ADDENDUM NO. 2 – July 14, 2026

**Lathrop Animal Center
CIP GG 23-11**

Project: Lathrop Animal Shelter
Project No: CIP GG 23-11
Date: 07/10/2026

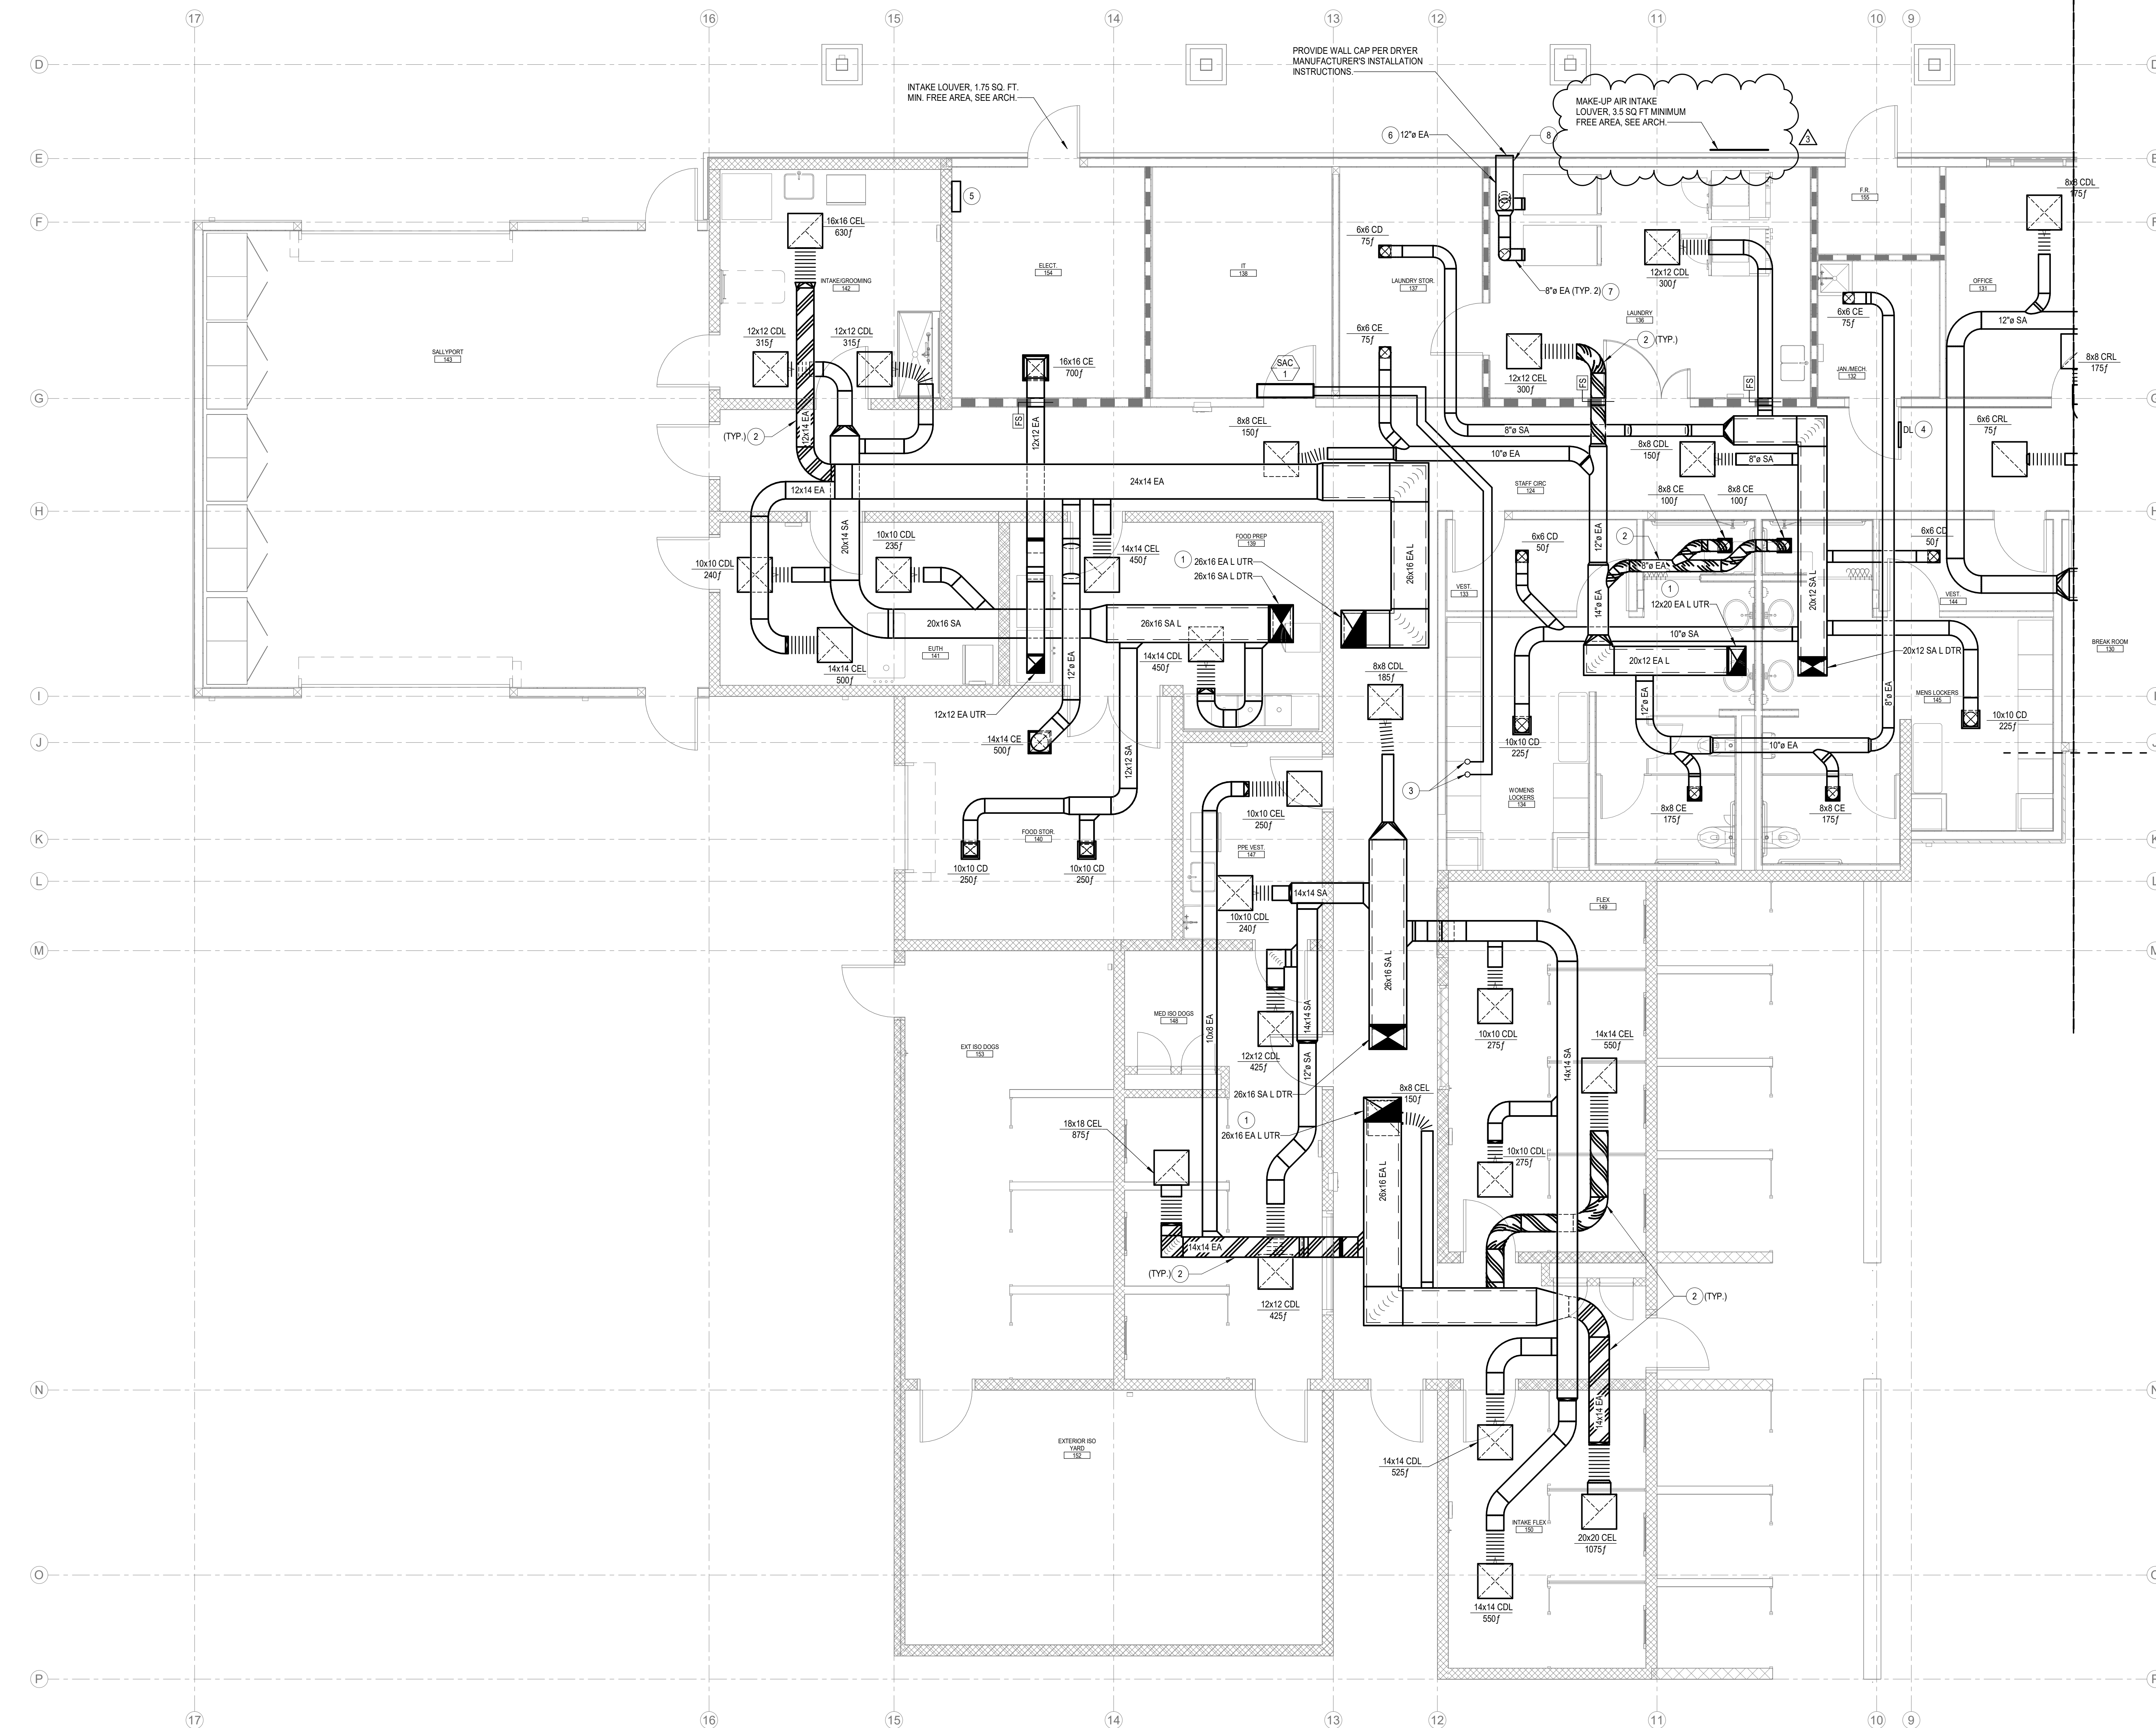
Does this FSD on Sheet M212 have to be aluminum or SS to line up with the aluminum ductwork?

For the dryer duct on Sheet M212 please clarify the following items:

2. Please confirm how the duct will mate up to the dryer.
3. Note 7 on Sheet M212 calls for access doors on bottom of each straight duct section. These doors are not mentioned in the dryer IOM. Please provide a detail clarifying exactly where the doors must go and how many are needed. Please also provide a product callout for these doors. If the inside of the duct must be smooth to prevent accumulation of lint then it seems the access doors will also need to meet that requirement. Most standard duct access doors are going to have some kind of inner lip or flange that would catch lint.

4. Note 8 on Sheet M212 says to seal space around duct through wall with noncombustible material, and Note 6 says to maintain 6" clearance to all combustibles. Does this mean that where the 12" duct exits the wall we need a 24" round opening stuffed with non-combustibles? Please provide a detail for this condition as it is not clear how this should be installed.

RESPONSE: Yes, combination fire smoke damper in branch duct serving laundry shall be of aluminum construction per keynote #2.

5. Make-up air louver shifted away from exhaust, new location exceeds 10' from exhaust outlet. See revised mechanical sheet M2.12 and revised architectural sheet A3.12
